City of Portland
Bureau of Development Services

Staff Presentation to the
Portland Design Commission

LU 15-279775 DZM, AD
Knight Cancer Research Building
KCRB

April 7, 2016

PARKING ENTRY SOUTH

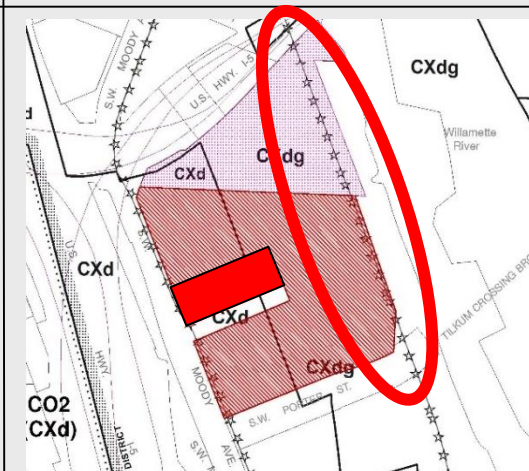
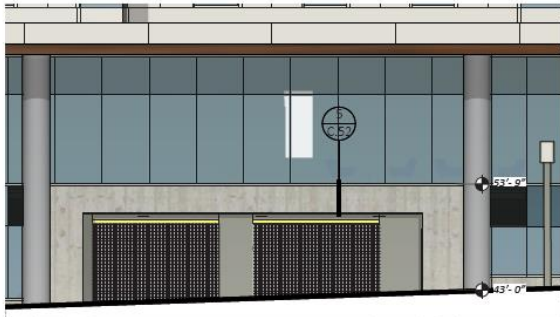
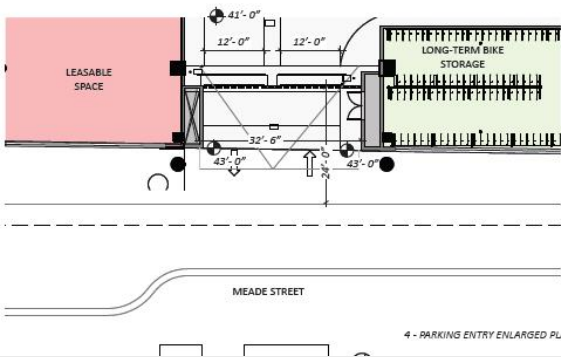
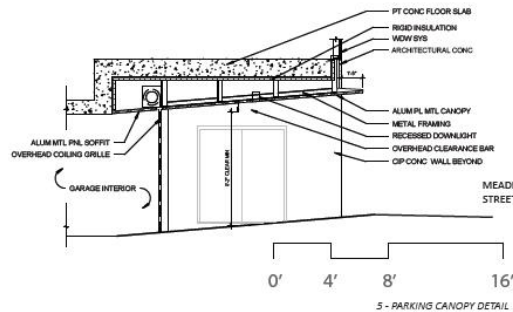
Issue 1: SW Meade Street frontage

Pedestrian safety

Street activation

Architectural coherency

LOADING DOCK

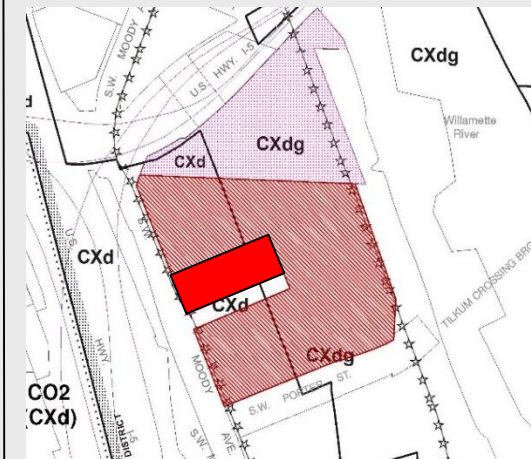
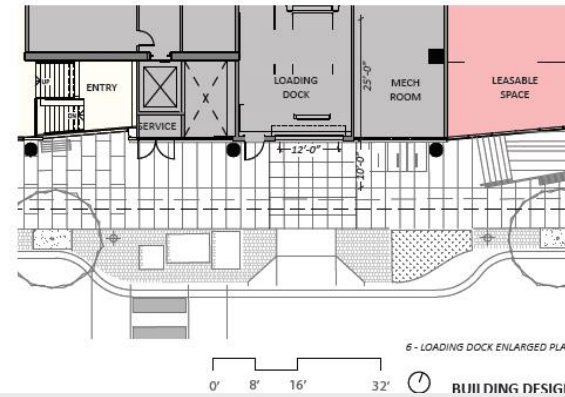
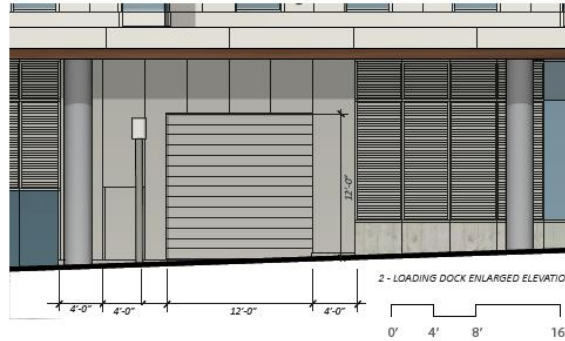
Issue 1: SW Meade Street ground level pedestrian safety, activation and architectural coherency

Design Guidelines and Modification not yet met:

A7-Establish and Maintain a Sense of Enclosure

A8-Contribute to a Vibrant Streetscape

B1-Reinforce and Enhance the Pedestrian System

B2-Protect the Pedestrian

C5-Design Coherency

Modification Request 3 – Ground Floor Active Use along SW Meade Street

WEST ELEVATION

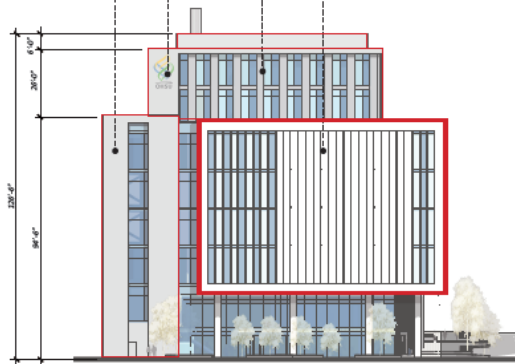
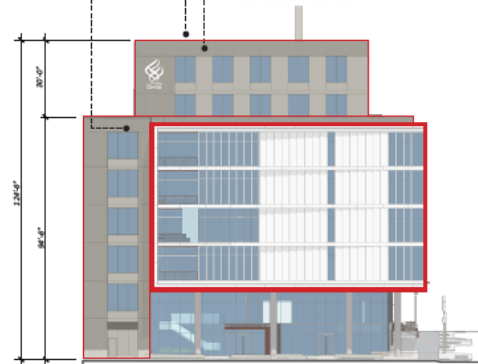
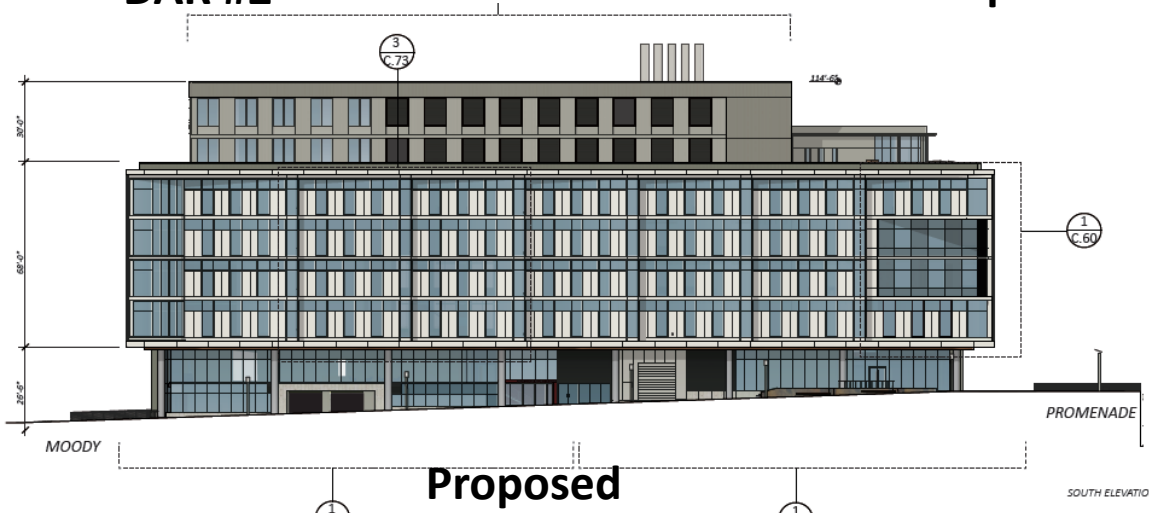
INCREASES PERCEIVED BUILDING HEIGHT

DARKER METAL PENTHOUSE DECREASES PROMINENCE AND STRENGTHENS LAB BLOCK CONCEPT

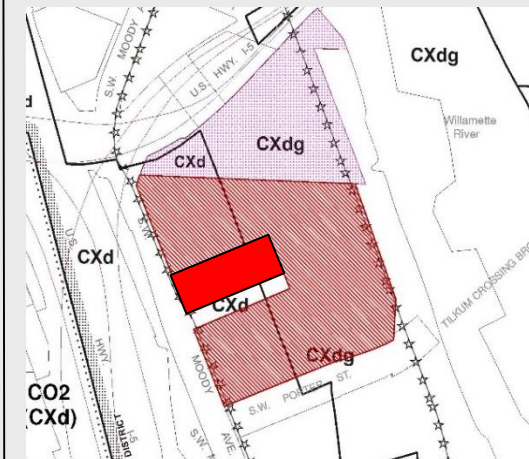
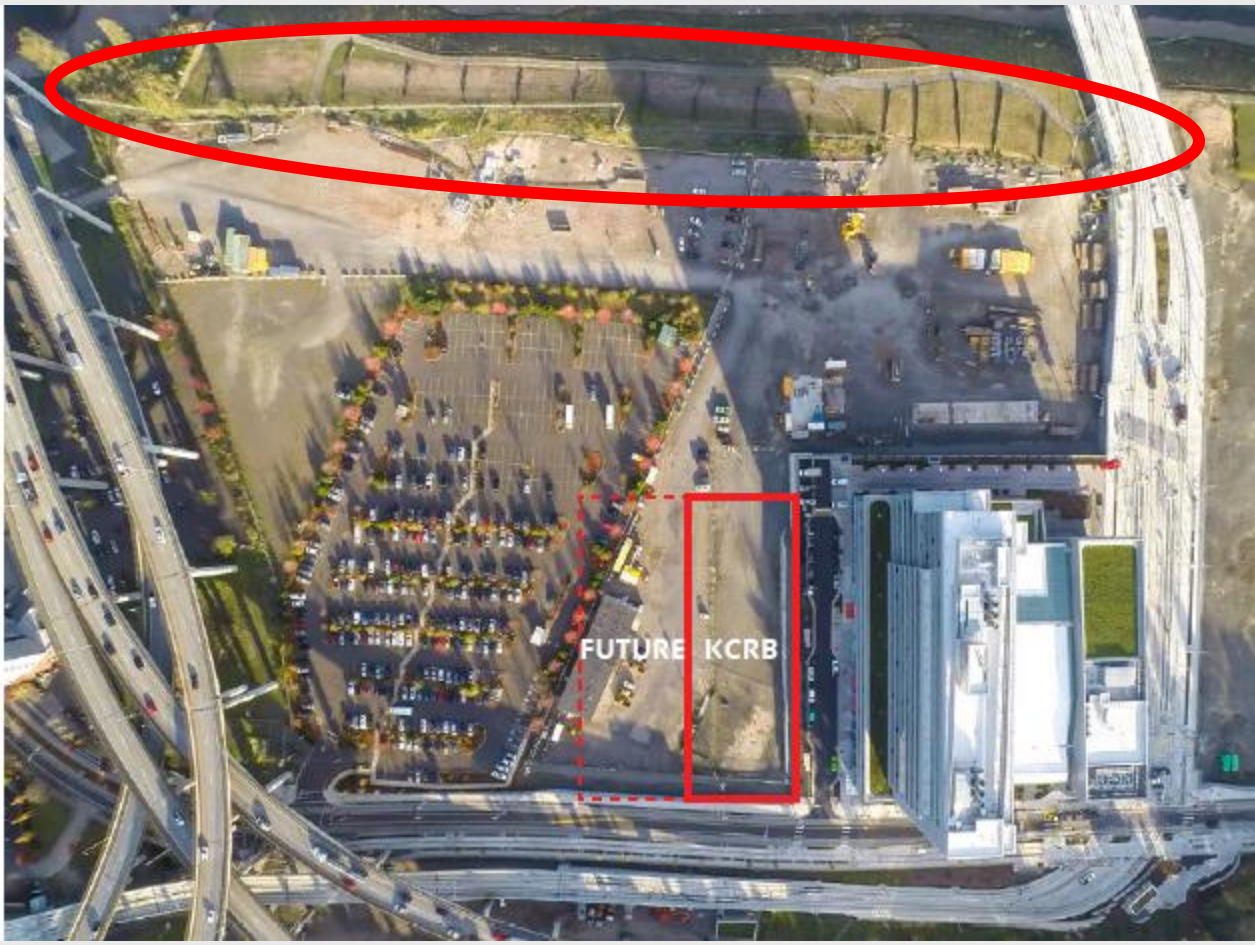
Issue 2: Rooftop penthouse integration and coherency

Design Guidelines not yet met:

C5-Design Coherency

C11-Integrate and Use Rooftops

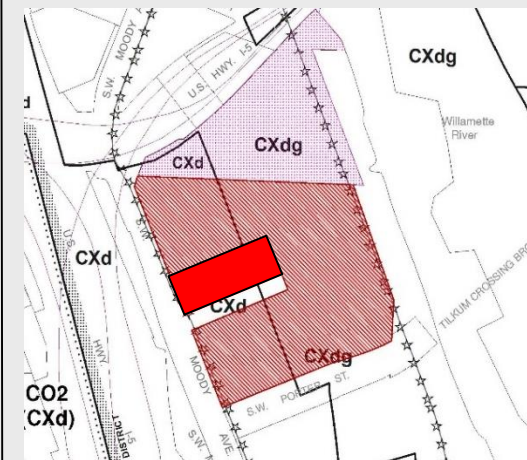
Issue 3: South Waterfront Greenway improvements

Design Guidelines not yet met:

1. Develop a Cohesive Greenway Trail System.
- 2-1. Address Streets and Accessways.
- 2-2. Address Adjacent Open Space.
- 2-3. Address Bridges.
3. Incorporate a Diverse Set of Gathering Places.
4. Integrate Materials, Structures, and Art.
5. Enhance the Riverbank.
6. Design Diverse Plant Communities.

West End of South Elevation

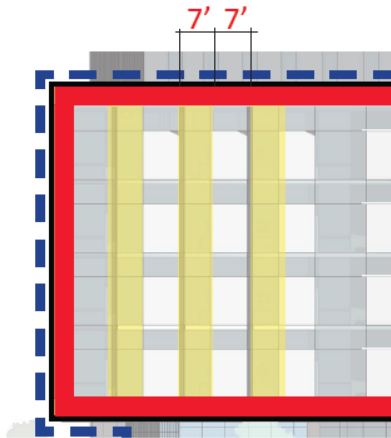
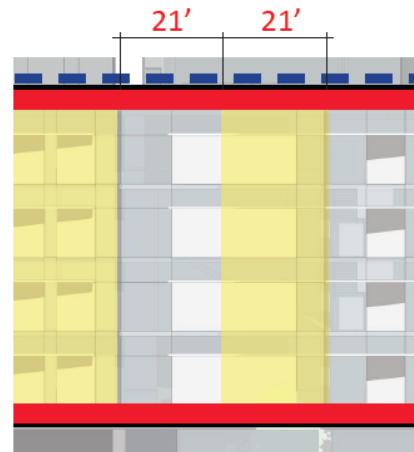
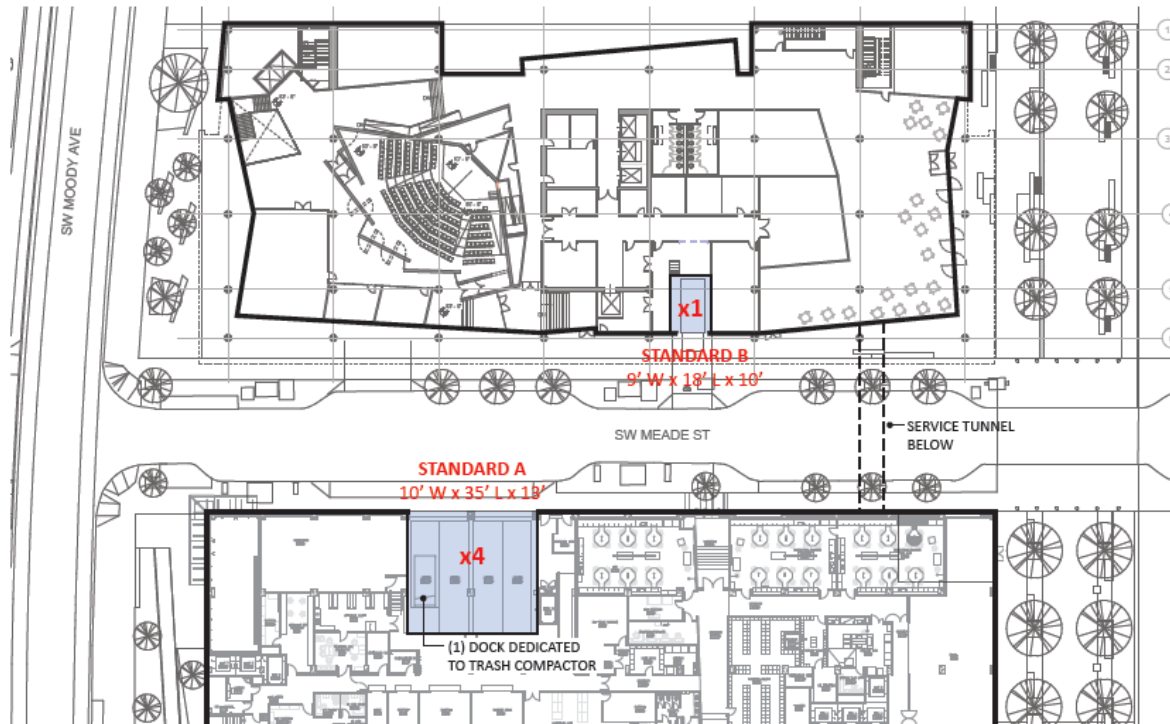
Modification – Required Building Lines

Required: The building must extend to w/in 12' of the lot line for 75% of the Meade and Moody frontage

Proposed: Meade – 49% and Moody – 31%

Exception – Oriel Windows

Required: Maximum 12' in length and minimum 12' separation

Proposed: Small oriels – 7' separation, large oriels – 21' in width

Adjustment – Loading

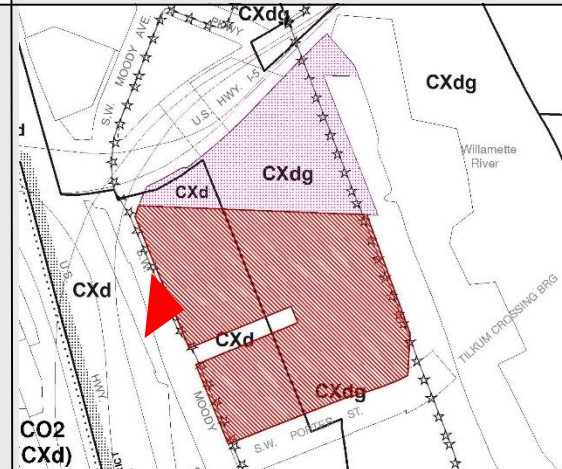
Required: 2 on-site spaces

Proposed: 1 on-site space
